Re: Section 4.55 (1A) modification to SSD 7424 (Smeaton Grange Waste Recycling and Transfer Facility)

This letter accompanies an application to modify the consent for SSD 7424 dated 22 December 2017 and is a Statement of Environmental Effects (SEE) for the application.

Site plans (Revision H, 10 May 2018)

Figure 2

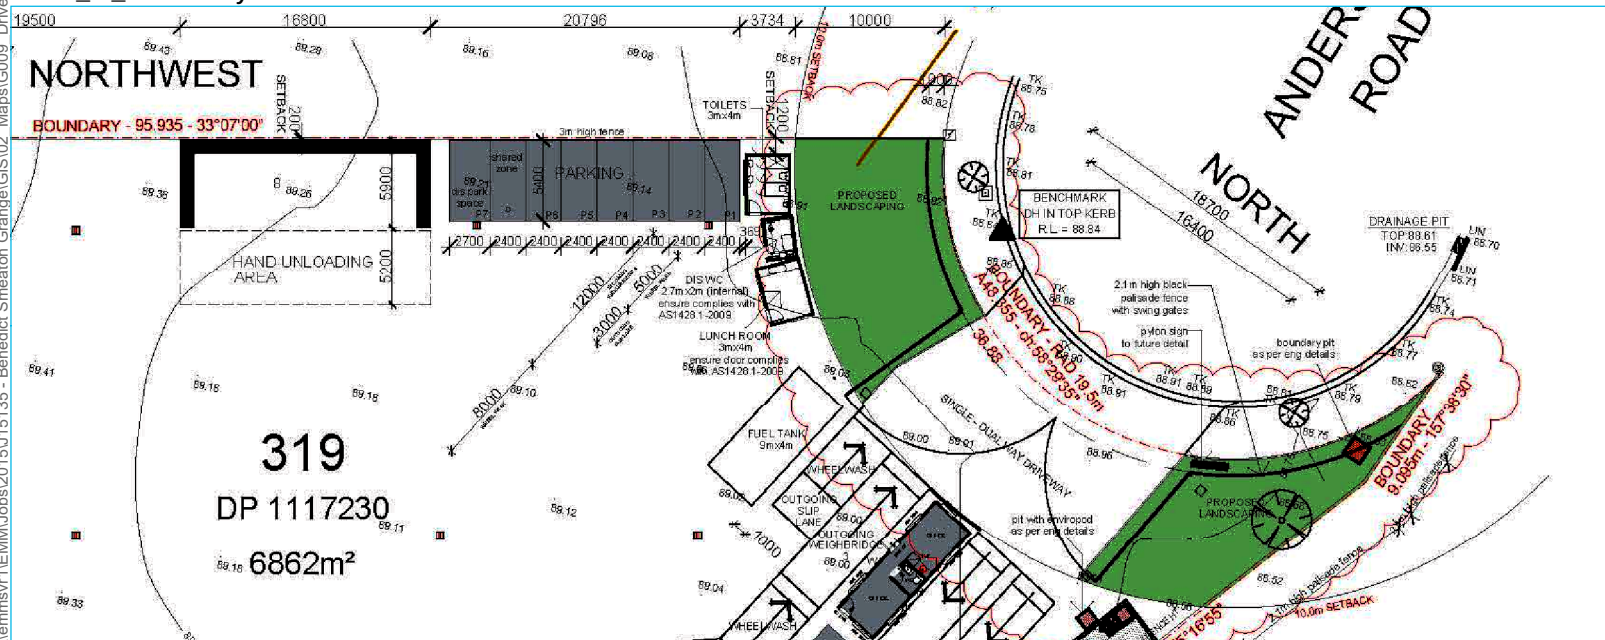
The proposed modification seeks to formalise the driveway foreshadowed in Section 3.6.5iv of the Response to Submissions dated 10 January 2017 (RTS). That section stated:

The proposed modification would allow for a driveway wide enough to accommodate the swept paths as described above and shown in shown in RTS Appendix F. A comparison of the driveway configurations is at Figure 2.

It is considered that the current consent approves the concept of a wider driveway, to be finalised as part of the construction certificate process. However, formalisation of the wider driveway through the proposed modification provides context for the detail design of the front boundary fence, to be approved by Council, as required by Condition B61.

drawing title
GROUND FLOOR PLAN

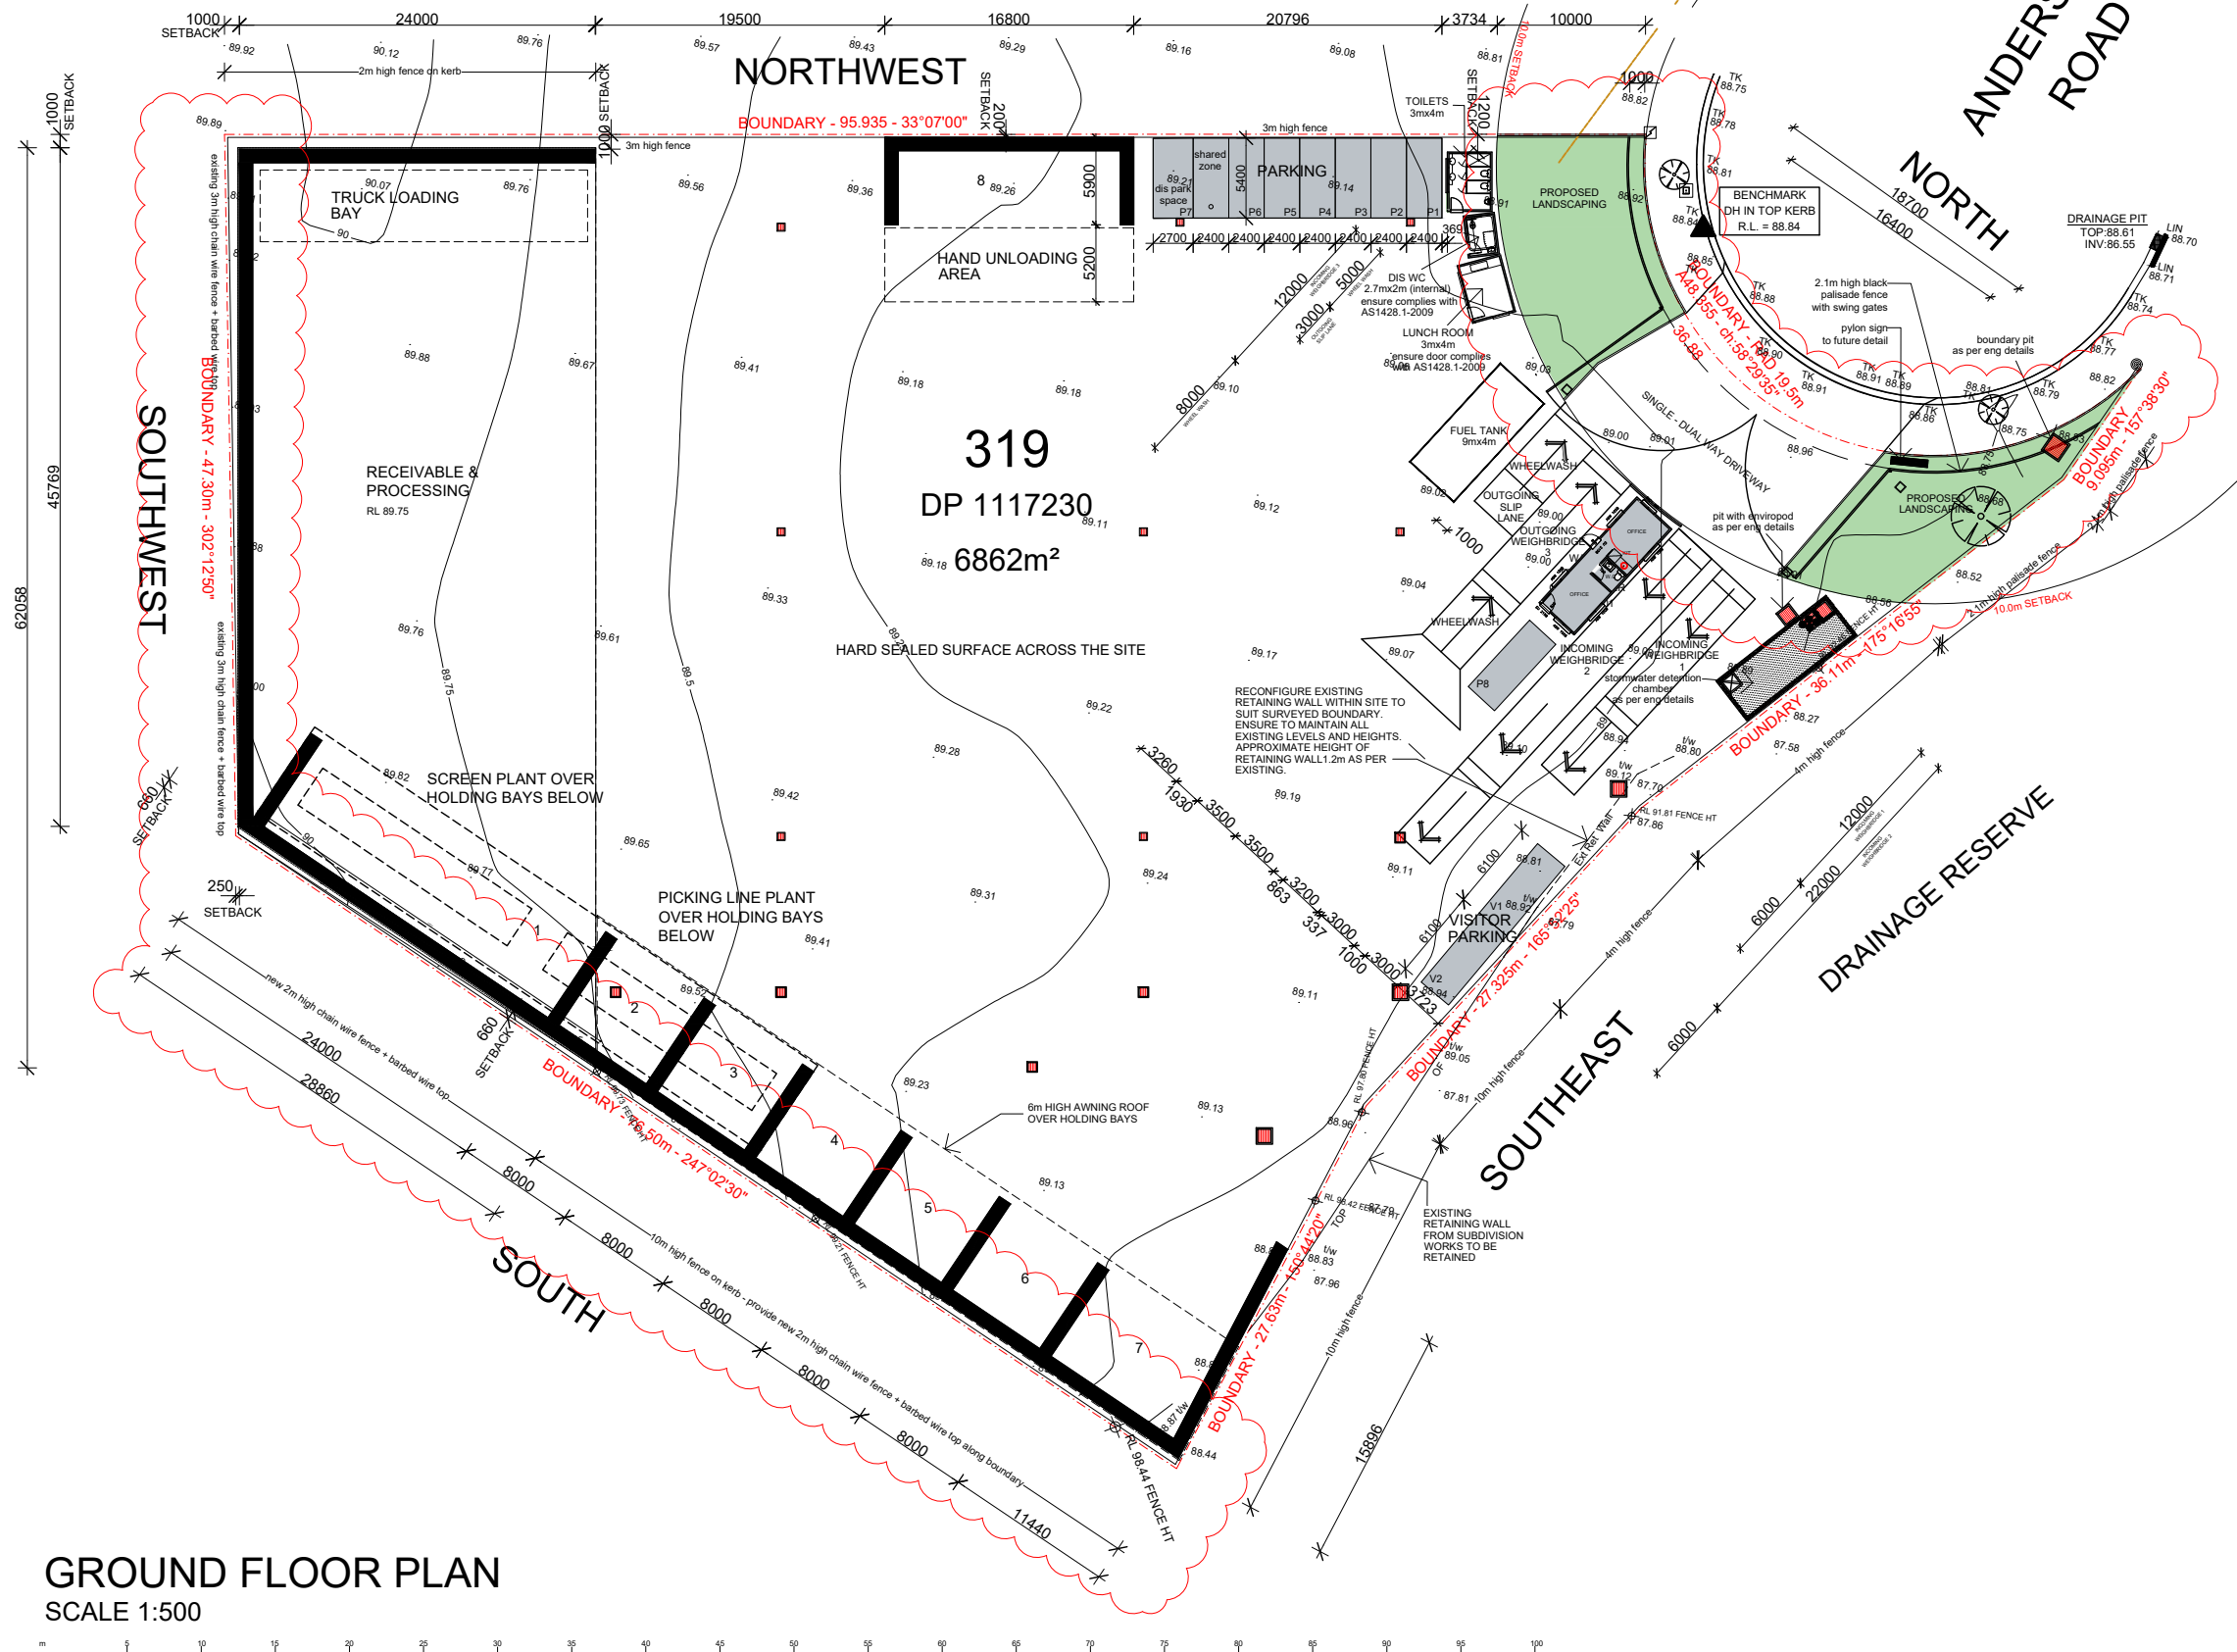
- change the 2 m tall solid boundary fence on the south-west boundary to a 3 m chain wire security fence with barbed wire (as exists currently);
- provide a 2 m chain wire fence with barbed wire top on the southern boundary;
- reduce the setback of the palisade fence from the front of the site (the northern boundary) from 10 m to 1 m;
- change the vehicle entrance from a sliding gate to an inward swinging gate; and
- update the driveway dimensions to reflect the swept path analysis requirements as noted in the Response to Submissions for SSD 7424 (RTS), dated 10 January 2017.

The proposed modification seeks to retain the style of the existing fencing between the site and the Coles site directly to the south-west. The existing plans show that the current 3 m wire security fence being replaced with a 2 m solid fence. Retention of the style of the existing chain wire fence will preserve the security of the Coles site, whilst minimising accessible surfaces for graffiti.

The proposed modification seeks to add a chain wire security fence on the southern boundary. While there is an existing palisade fence at the boundary, it has been determined that a chain wire security fence would be more appropriate as it would further minimise accessible surfaces for graffiti (ie the wide surfaces of the palisade fence and the rear cladding of the bay walls accessible by standing on top of the palisade fence). A security topping, ie a barbed wire topping (similar to the neighbouring Coles fencing), or looped security wire, would prevent access to the site, as well as deter potential vandals from standing atop the fence.

The proposed modification seeks to reduce the setback of the entrance fencing and gates from 10 m to 1 m. The material and size of the entrance fencing and gates, approved as a 2.1 m tall black palisade fence, will not change. The form of the gates will be changed from sliding gates to inward swinging gates. The 10 m landscape area is not proposed to be reduced.

The drawings dated 10 May 2018 (Revision H), attached at Appendix A have been prepared to replace the approved drawings for the facility. The drawings relate to the proposed changes outlined below.
